Memorandum

Subject: PUD-09-01/SUB-09-01/WAP-09-02 Suncrest PUD

This memo addresses issues raised at the last public hearing related to the proposed conservation area. Also attached to this memo is new staff and citizen input received since the June 17 hearing as well as two new proposed Conditions of approval (Numbers **16** and **17**) for the PC to consider.

Current Overhead View, 1810 Carriage Way, zoom in, view of natural foliage

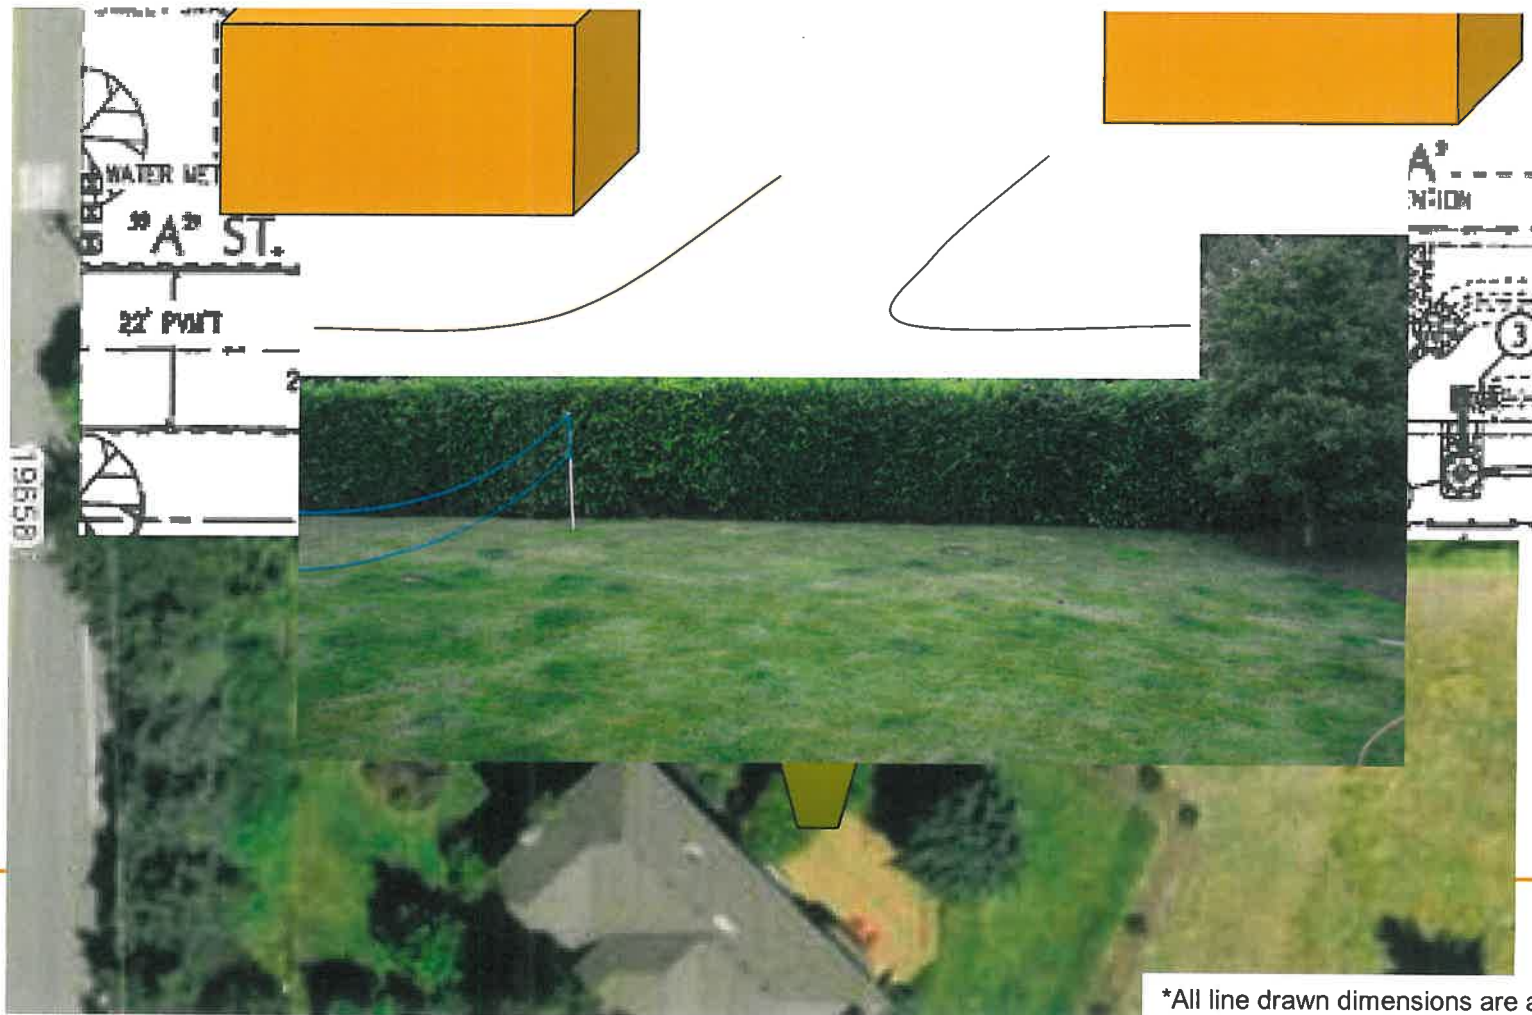
Natural, mature trees =
“...existing character and quality of West Linn”*

Laurel Hedge

Character destroyed, privacy compromised

16. **The applicant shall preserve the laurel hedge along the border of the subject property and 1810 Carriage Way, and shall protect the health and root systems as best as possible throughout the construction process.**

Proposed Development View, 1810 Carriage View from new development, privacy compromised

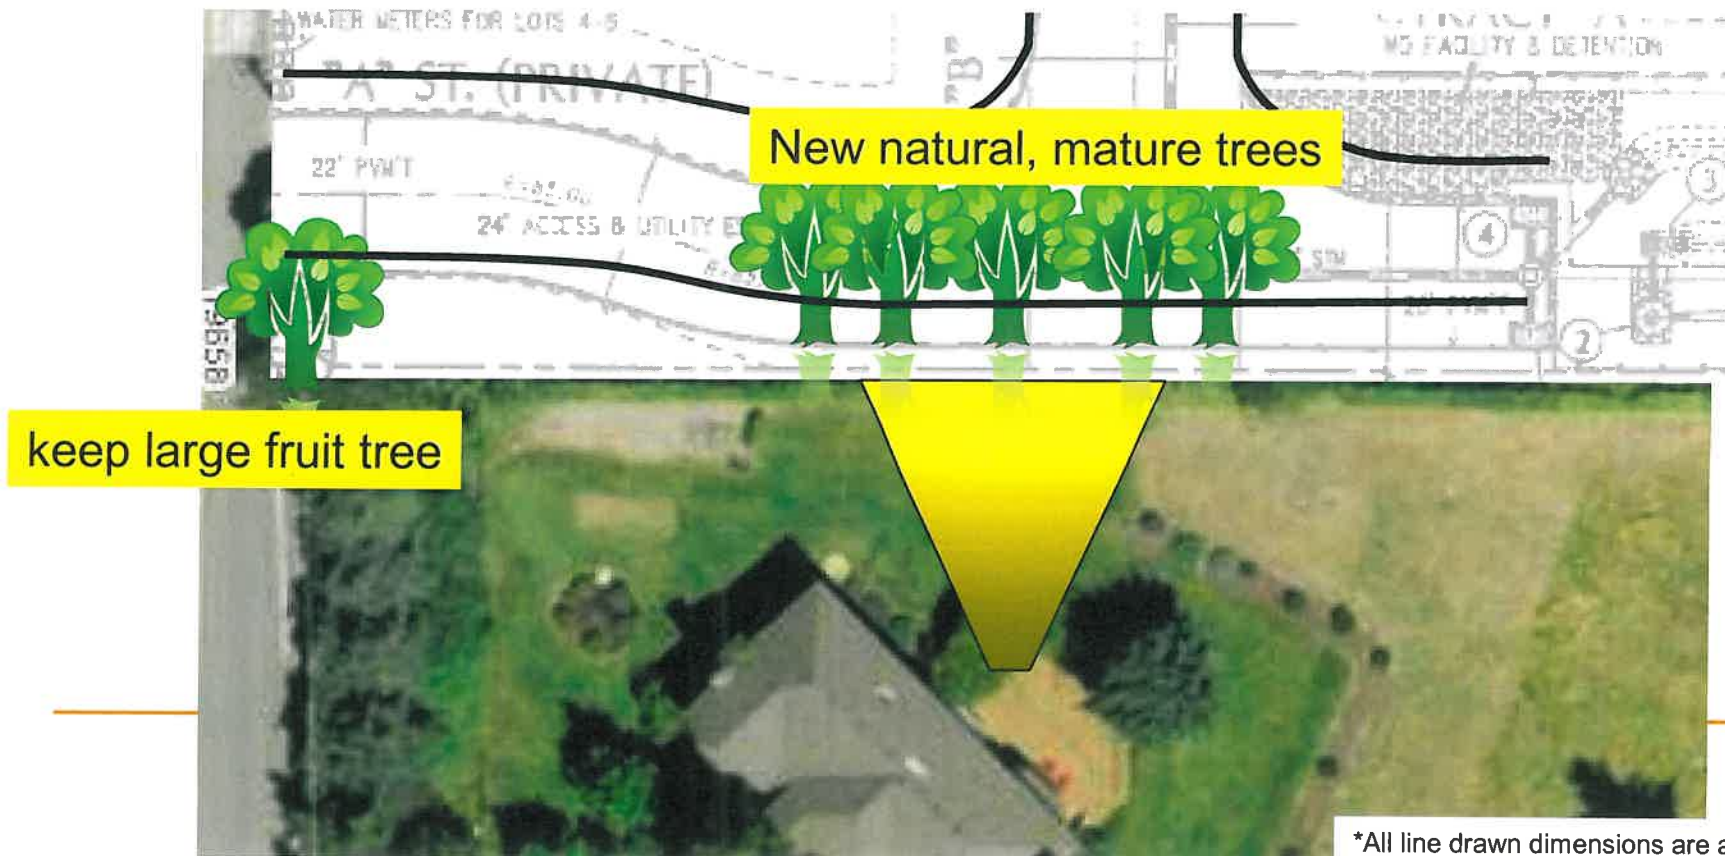
Request to maintain natural environment,
value of current home—

Trees at boundary, road offset slightly to
accommodate privacy foliage

Proposed Development View, 1810 Carriage
 New trees → View from new homes
 privacy maintained, value maintained =
 “appropriate transition”
